TOWN OF YARMOUTH
200 Main Street, Yarmouth, Maine 04096
www.yarmouth.me.us

Planning Board Report
Travis Roy Arena, 497 Route One
Preliminary Plans for Building & Lot Plan & Major Site Plan
North Yarmouth Academy, Applicant
Map 32 Lot 125; SD-1 NYA Campus Special District
Prepared by Julie Dubovsky, Assistant Planner, and Erin Zwirko, Director of Planning and Development

Proposed Rendering of Arena Expansion

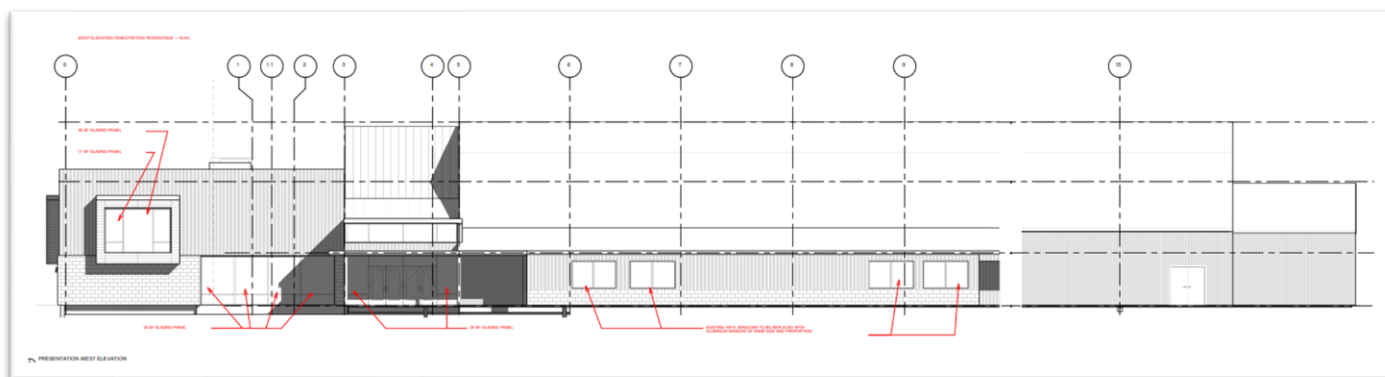
The existing building is a prefabricated metal clad structure. As described in the materials, the existing West facing facade is a combination of fenestration, masonry, and vinyl clapboard profile siding. This facade is intended to be re-clad with new masonry and wood grain textured metal panels that correspond to the proposed addition. The proposed design of the facade includes three materials: the primary corrugated metal panel, a secondary metal panel that will be of a different texture and color, and a masonry unit either consisting of brick or ground face block to match the existing institutional qualities of the campus.

As described further in the materials, the proposed addition consolidates several varying roof conditions into one cohesive form. The existing entry vestibule is converted into interior program space. The remaining existing slab is repurposed for a new principal entry vestibule. A new canopy over the entrance also highlights the rhythm of material change and signifies the prominence of the main entry point.

Proposed North Elevation

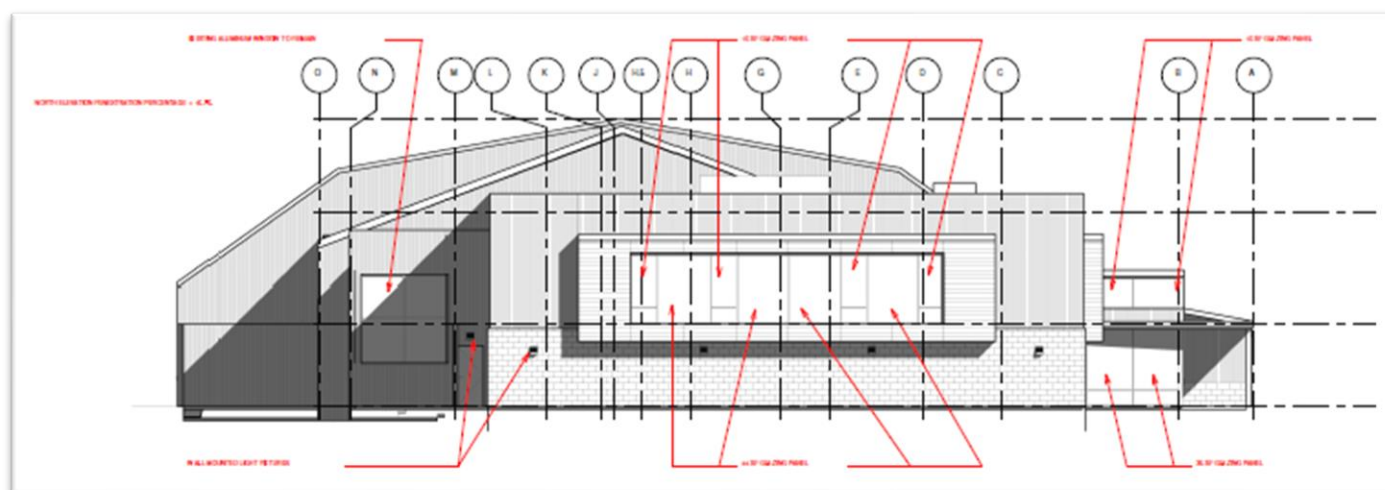
The proposed arena design is institutional in nature, which may be appropriate for the expansion of a pre-existing building. The façade materials include the primary corrugated metal panel, a secondary metal panel that will be of a different texture and color, and a masonry unit either consisting of brick or ground face block to match the existing institutional qualities of the campus. The building includes a new main entrance, and the proposed addition is a two-story expansion as shown in the rendering below.

The applicant has identified the need for one waiver from the requirement that single glass panes be no larger than 20 square feet (Section C.4i). In reviewing the renderings during the Concept Review meeting, the applicant indicated that the design does exceed the requirements but matches the scale and proportion of the contemporary design, as well as the existing building and its proportions. The applicant is also requesting a waiver for the requirements to provide a minimum of 20% glazing per façade (Table 5.F.2A Façade Glazing), due to the building's primary function as an ice arena.
